## Goldpark King No. 2 Revised Trenching Program 5/31/23 CDRMS File P-2023-004

**EVALUATION TRENCHING PROGRAM**  
**GOLDPARK KING NO. 2 PLACER CLAIM**

**Revised & Supplemented**

**Final Plan: May 31, 2023**

#### TYPICAL TRENCHING SITE PLAN

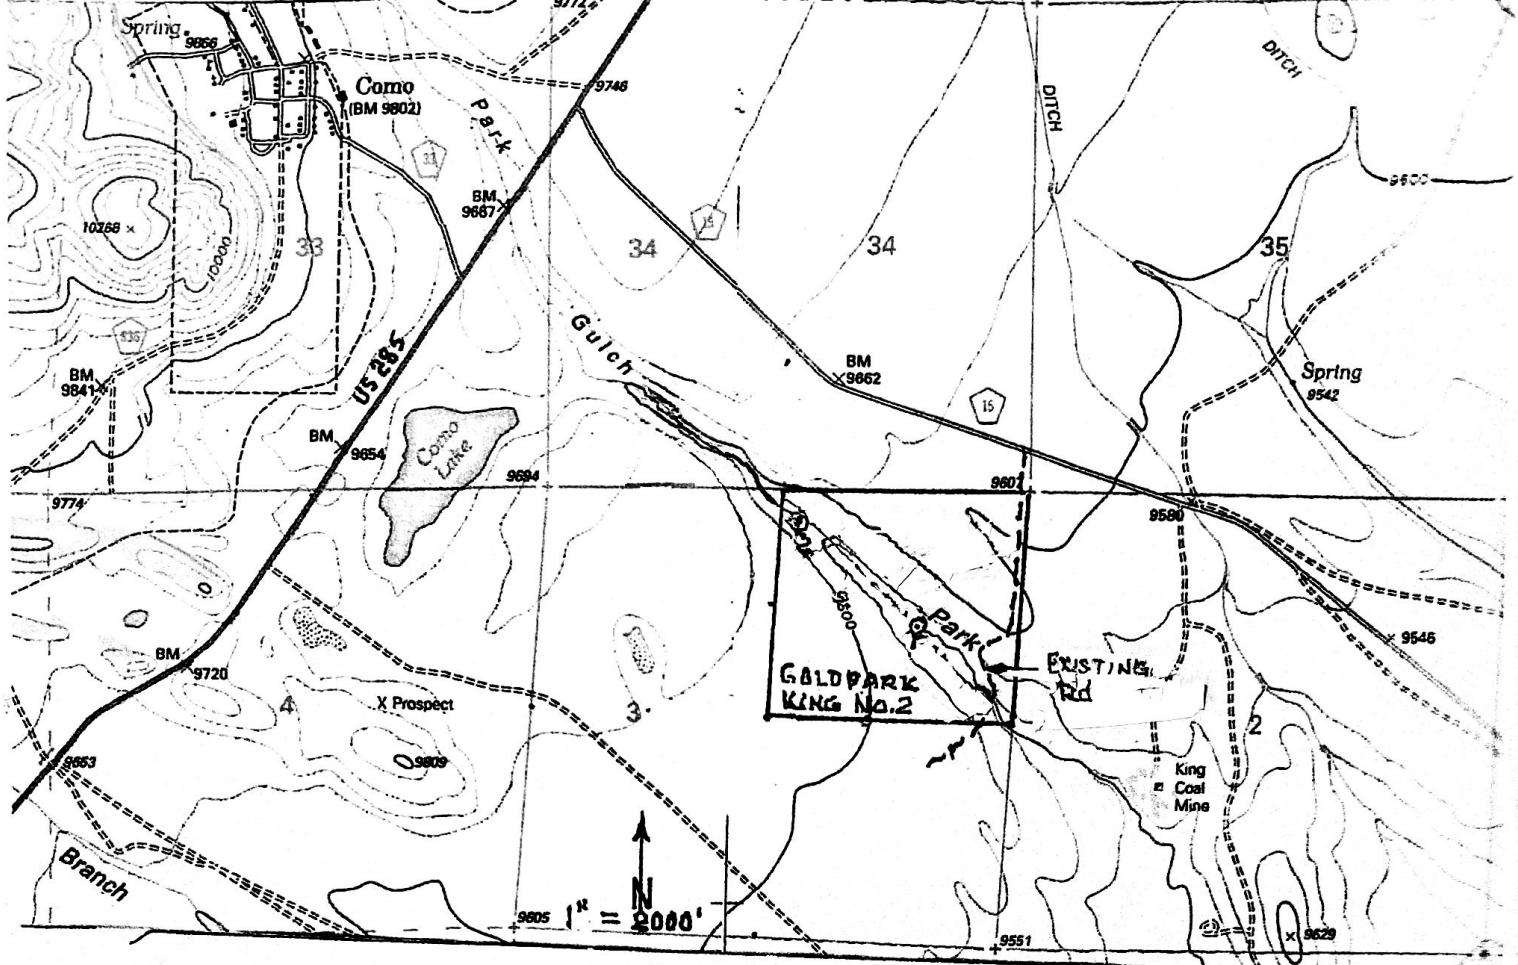
**The attached typical site plan shows, for each trenching site, the estimated surface disturbance directly caused by excavation, and the surface area affected by light grading, movement of personnel and equipment, and placement of gravel and topsoil piles. The general location of piles of excess topsoil and 6-12 inches of topsoil and surface vegetation are shown on the attached site plan. All together, the surface area affected by trenching and related activities is estimated to be as listed below.**
